**STAFF RECOMMENDATION**  
**1117 McKennie Avenue**  
**March 20, 2019**

**Application:** Demolition--Partial Demolition of Outbuilding/ DADU; Setback Determination

**District:** Lockeland Springs-East End Neighborhood Conservation Zoning Overlay

*Site Planning & Setbacks:*

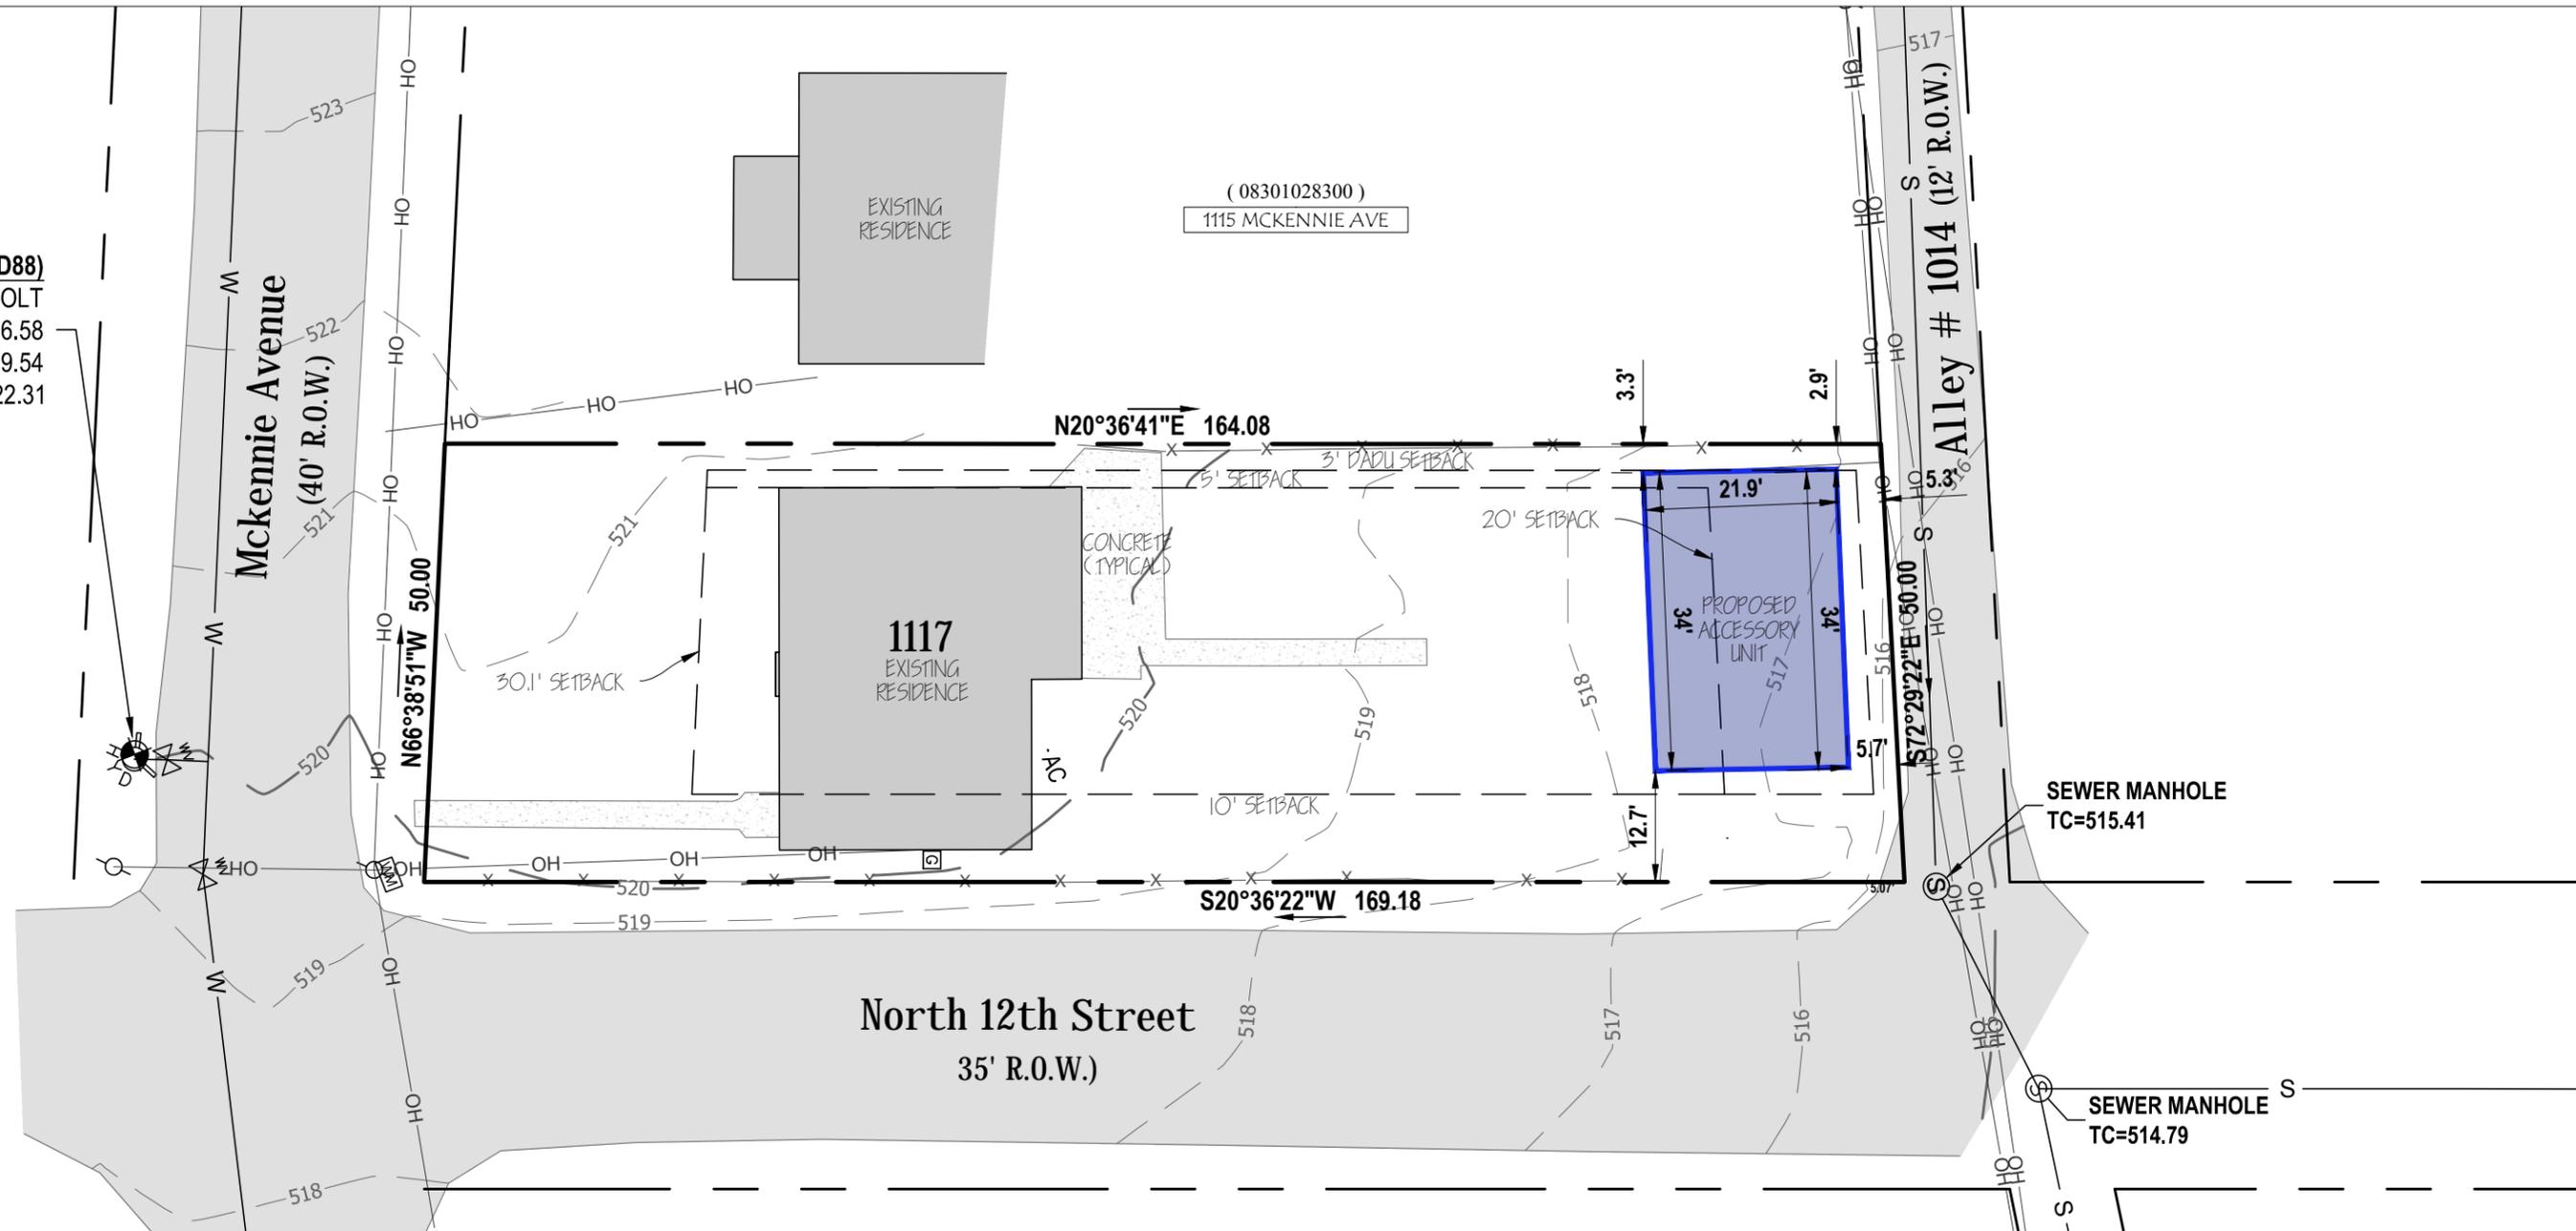
<b>MINIMUM</b>	<b>PROPOSED</b>
Building located towards rear of lot	-	Yes
Space between principal building and garage	20'	63'
Rear setback	5'	5'
Left side setback	5'	2'11"*
Right side setback	10'	12'
How is the building accessed?	-	No Garage Doors
Two different doors rather than one large door (if street facing)?	-	No Garage Doors

\* The DADU ordinance states that the structure should meet the base zoning setbacks. For an outbuilding that is larger than seven hundred square feet (700 sq. ft.) like this one, base zoning requires that the side setback should be a minimum of five feet (5'). In this case, the existing structure is as close as two feet, eleven inches (2'11") from the left side property line. Since the structure is existing and will not extend further into the side setback than it does currently, staff finds that converting the existing structure into a DADU is appropriate.

Staff finds that the DADU's height, scale, location, known, materials, setback, and design meet the design guidelines and the DADU Ordinance 17.16.030.G.
